## DEVELOPMENT APPLICATION ASSESSMENT REPORT

<b>Application Number:</b>	DA2022/0374
----------------------------	-------------

<b>Responsible Officer:</b>	Kye Miles
<b>Land to be developed (Address):</b>	Lot B DP 390788, 1744 Pittwater Road BAYVIEW NSW 2104 Lot PO 164136, 1744 Pittwater Road BAYVIEW NSW 2104
<b>Proposed Development:</b>	Demolition works and construction of a dwelling house including a swimming pool and boat shed
<b>Zoning:</b>	C4 Environmental Living
<b>Development Permissible:</b>	Yes
<b>Existing Use Rights:</b>	No
<b>Consent Authority:</b>	Northern Beaches Council
<b>Land and Environment Court Action:</b>	No
<b>Owner:</b>	Helen Marie Bragg
<b>Applicant:</b>	Helen Marie Bragg

Figure 3. View loss analysis from No. 1746A Pittwater Road's kitchen window.

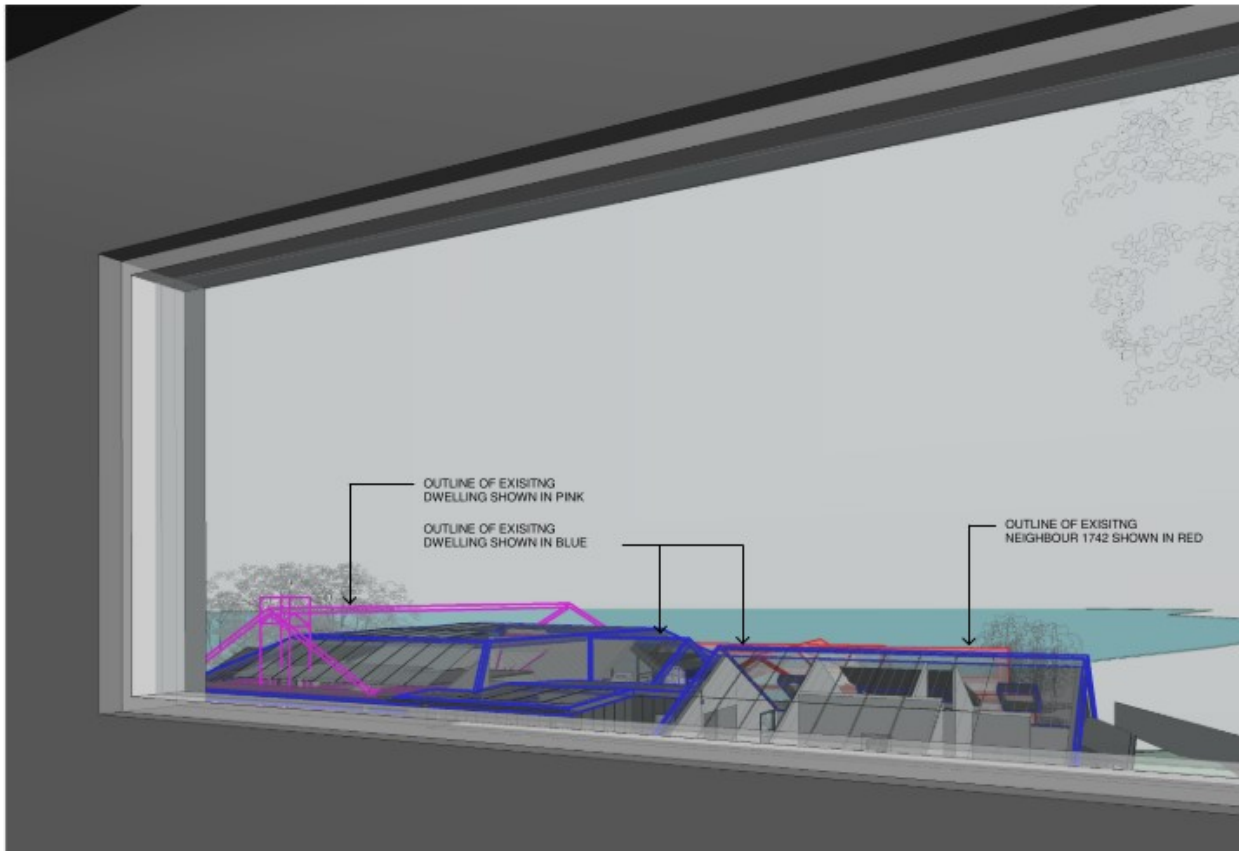
From the first floor kitchen - The impacted areas involve views from the kitchen window, which would include a minimal reduction of water views as demonstrated in figure 3 below. In addition, the expansive water views from the first floor balcony remain unimpaired by the proposal. Given the extent of view loss is minimal and that the impacted views are taken directly across the side boundaries the view loss is considered negligible in the context of these principles.

**Figure 1:** Envelope breach on the western elevation shown in red.

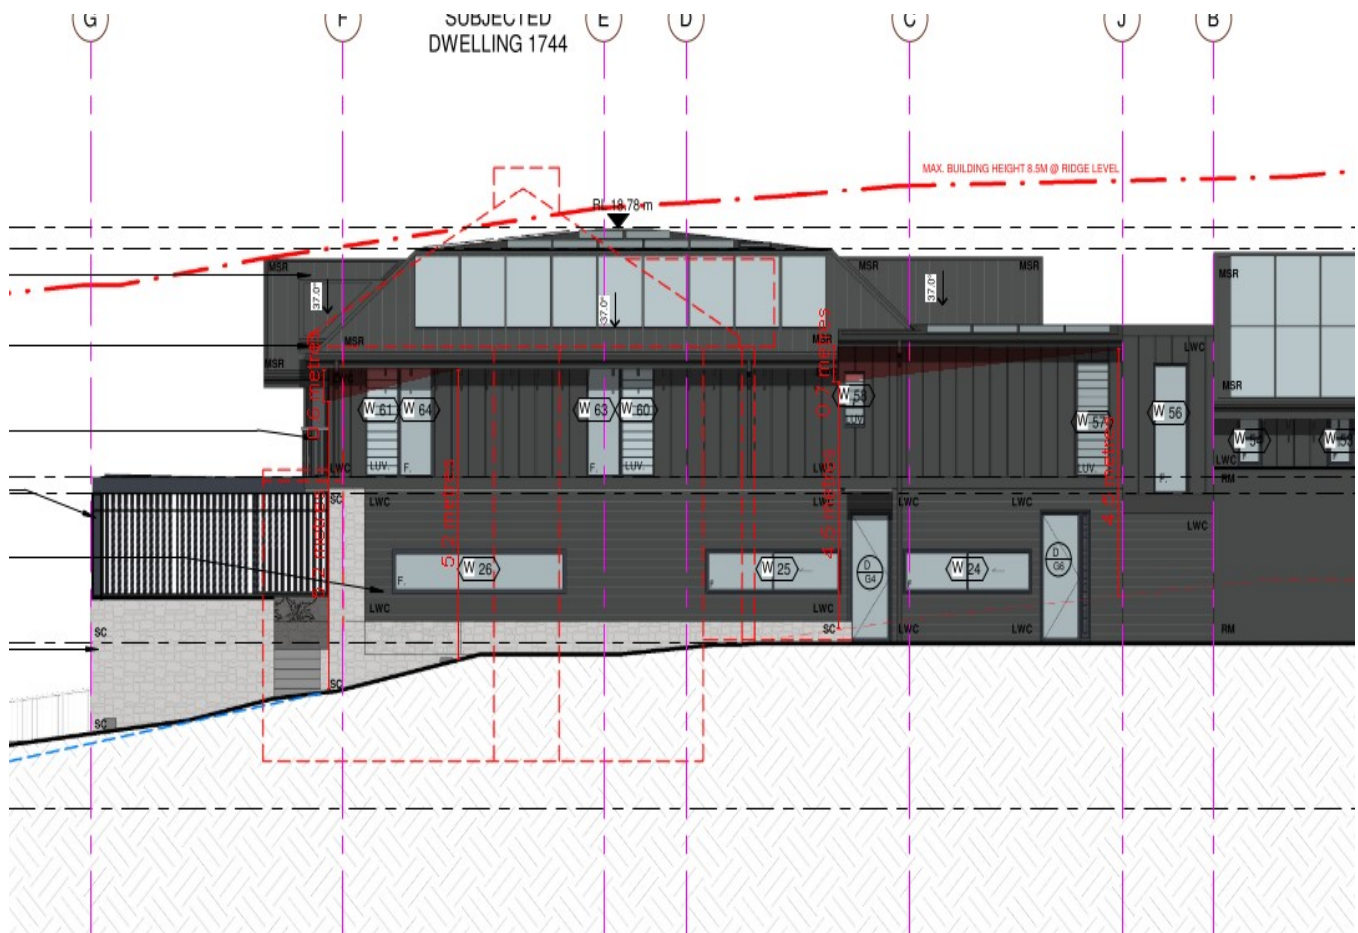
The DCP requires that the building be within a building envelope measured at 45 degrees from 3.5m above the side boundary line.

The proposal has a non-compliance to the building envelope on the western elevation. The extent of the building envelope non-compliance is shown in the figure below (highlighted in red):

Clause D4.8 permits a variation which permits eaves or shading devices to extend outside the building envelope. As such the proposed roof eaves and balcony roof has not been included within this assessment.
